**COMMENT RESPONSE DOCUMENT (CRD)
TO NOTICE OF PROPOSED AMENDMENT (NPA) 2008-01**

***"Extended Range Operations with Two-Engined Aeroplanes ETOPS Certification and
Operation ("AMC 20-6")***

Explanatory Note

Figure 1

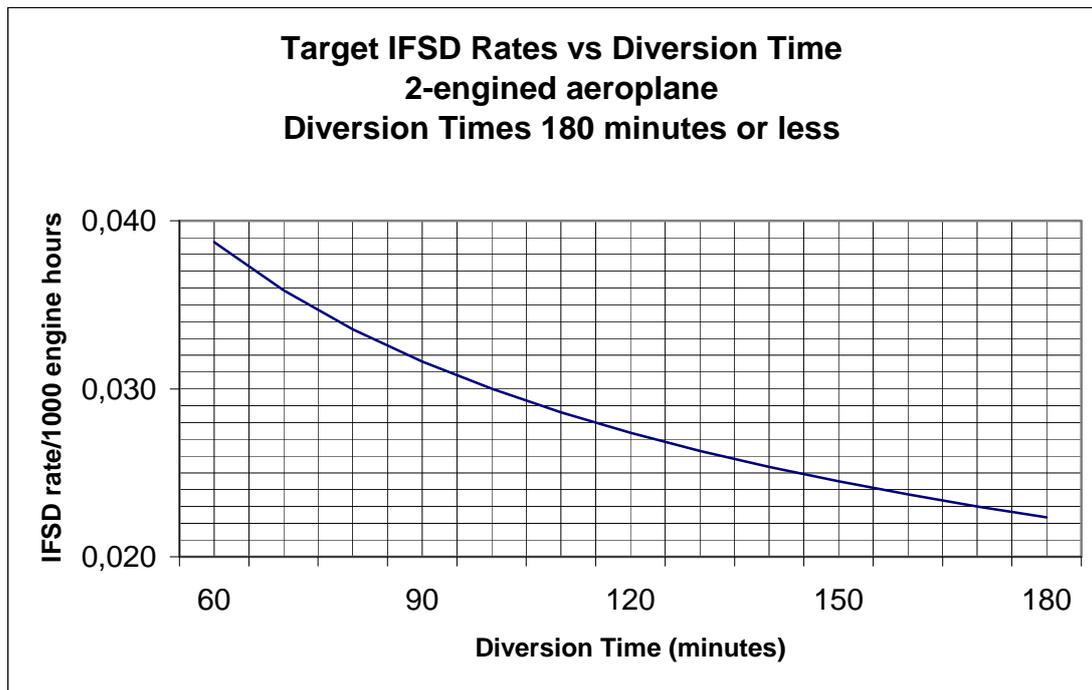
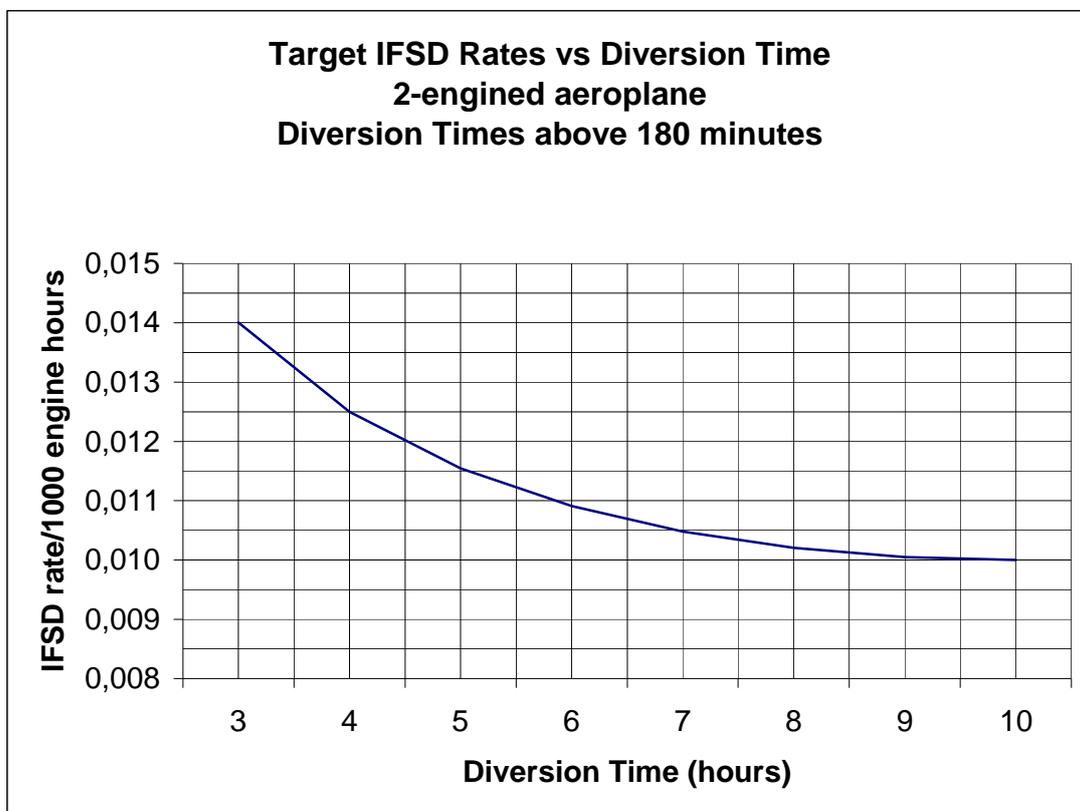
Page 83: **Part B, VII. Draft Decision amending AMC-20:**
Appendix 1 - Propulsion System Reliability Assessment, 3 Risk Management and Risk Model, a. Figure 1, Page 82; and b.(5), Figure 2

Boeing notes that the target IFSD rate for 180-minute diversion time in Figure 1 conflicts with the target IFSD rate for 3-hour diversion time in Figure 2. We suggest that the graph line in Figure 2 start just after 3 hours to avoid the conflict.

Comment: Discrepancy between figure 1 and figure with regard to the target IFSD rate for diversion times of 180 minutes.

Figure 1 shows for 180 minutes a target IFSD rate of ± 0.022 .
Figure 2 shows for 180 minutes a target IFSD rate of ± 0.014 .

We fail to understand the significant difference of the target IFSD rate between figure 1 and 2.

According to Figure 1, the IFSD Rate must be < 0.0225 at 180 minutes, while according to Figure 2, the IFSD Rate must be < 0.014 at 180 minutes.

- How ETOPS 120 min approvals are considered. An IFSD rate of 0.05/1000E.H is required (in plain text) in the current AMC 20-6, as well as in current FAA ETOPS rule (Appendix K to Part 25). This plain text value is no more available in this NPA. The curve provided in figure 1 reads an IFSD rate objective in the order of 0.027/1000 EH.
